PLANNED UNIT DEVELOPMENT MODIFICATION AT SQUARE 50

2201 M Street, NW
Washington, DC

STAFF RECOMMENDATION

NCPC File No. ZC 07-21B

Roof plan of the current proposal (the modification to the previously approved PUD) with setback dimensions for rooftop structures

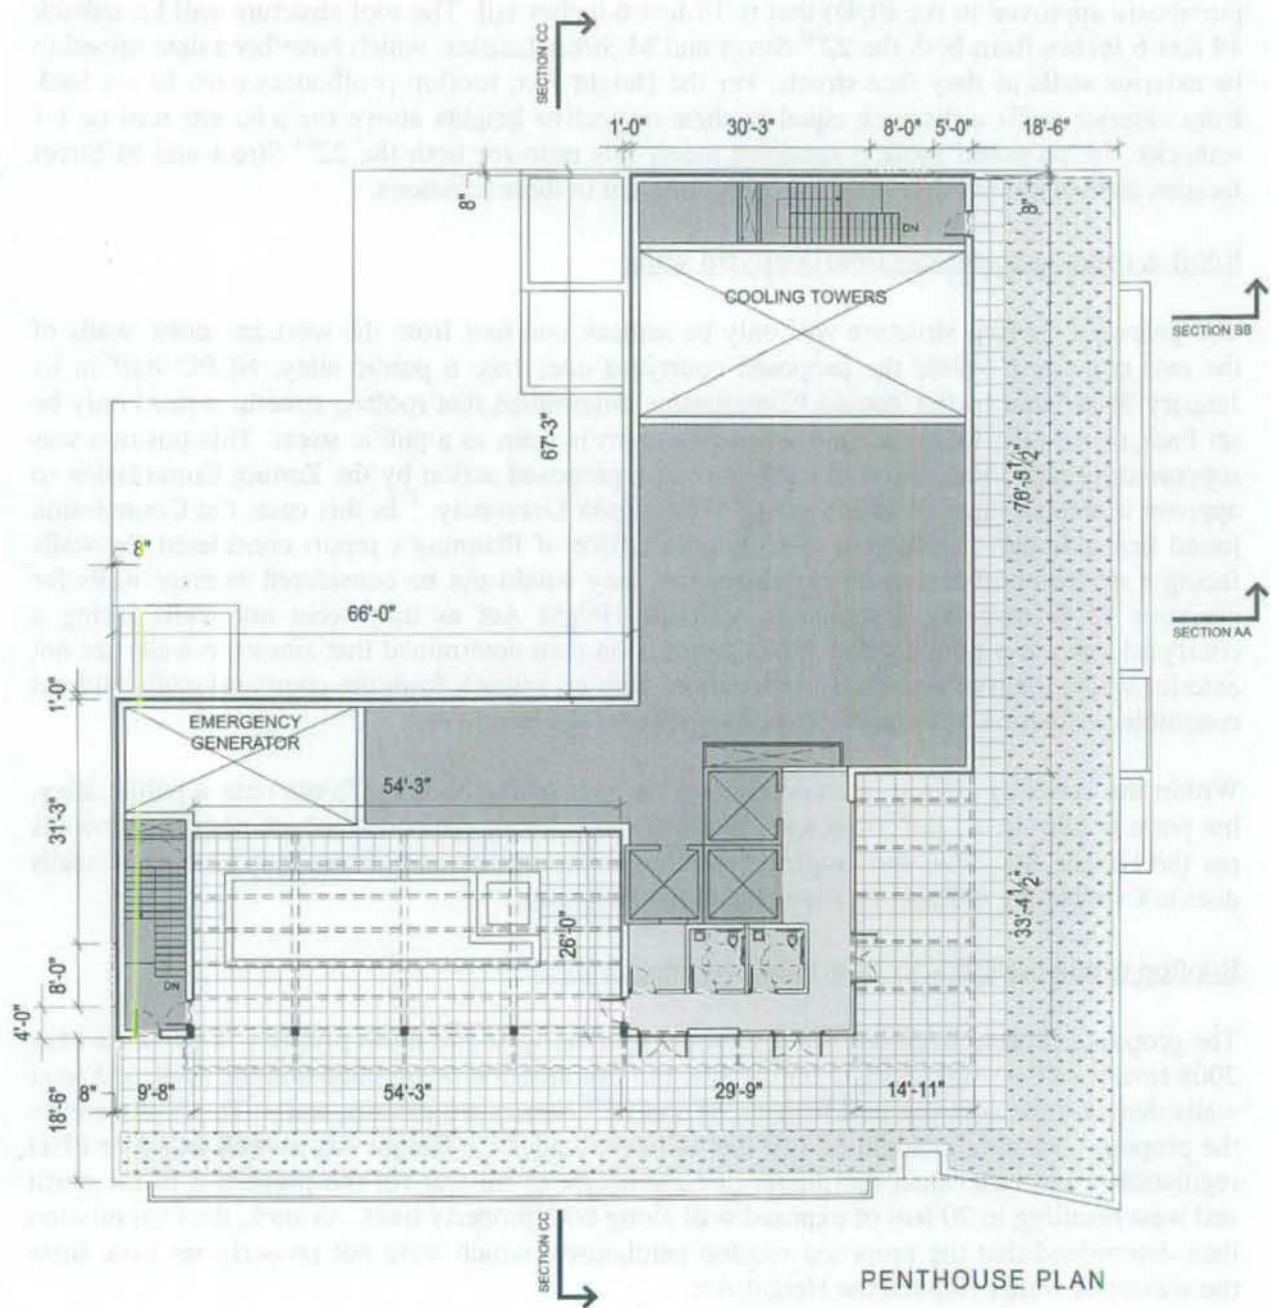
Rooftop penthouse setbacks from streets

previously approved in the PUD) that is 18 feet 6 inches tall. The roof structure will be setback 18 feet 6 inches from both the 22nd Street and M Street facades, which have been determined to be exterior walls as they face streets. Per the Height Act, rooftop penthouses must be set back from exterior walls a distance equal to their respective heights above the adjacent roof (a 1:1 setback); the proposed rooftop structure meets this ratio for both the 22nd Street and M Street facades and thus meets this Height Act requirement in these locations.

The proposed rooftop structure will only be setback one-foot from the west and north walls of the rear courtyard. While the proposed courtyard does face a public alley, NCPC staff in its January 2009 letter to the Zoning Commission, determined that rooftop structures need only be set back from walls facing a court when that court is open to a public street. This position was supported by the Commission in its review of a proposed action by the Zoning Commission to approve a second stage PUD at George Washington University.² In this case, the Commission found that although the District of Columbia Office of Planning's report considered the walls facing a closed courtyard to be exterior walls, they would not be considered exterior walls for purposes of determining compliance with the Height Act as they were not walls facing a courtyard open to a public street. The Commission then determined that since the walls are not exterior walls, the rooftop penthouse location, with no setback from the courtyard walls, did not constitute a violation of the setback requirements of the Height Act.

Within the current proposal, the courtyard at the rear of the building fronts onto a public alley, but not a public street, and as such the building walls facing the courtyard are not exterior walls per the Height Act. Thus the proposed rooftop penthouse setback of one-foot from these walls does not violate the setback requirements of the Height Act.

The proposed rooftop structure is not setback from the west and north property lines. In its May 2008 review of the original PUD for the site, the Commission determined that the north and west walls that abut the adjacent buildings on M and 22nd Streets are exterior walls. This was because the proposed building's height of 110 feet (allowed under the Height Act as well as under PUD regulations) was taller than the matter-of-right height of 90 feet for the properties to the north and west resulting in 20 feet of exposed wall along both property lines. As such, the Commission then determined that the proposed rooftop penthouses, which were not properly set back from these exterior walls, violated the Height Act.

Within the current proposal, the walls along the property lines of the adjacent properties both north and west of the site can be considered, for their full height, party walls under the Height Act. This is due to the fact that the properties both north and west of the site could be built to the same 110-foot height as the subject property under the Height Act (given M Street's or 22nd Street's 90-foot rights-of-way). Thus, the lack of rooftop penthouse setbacks from these walls does not violate the requirements of the Height Act.
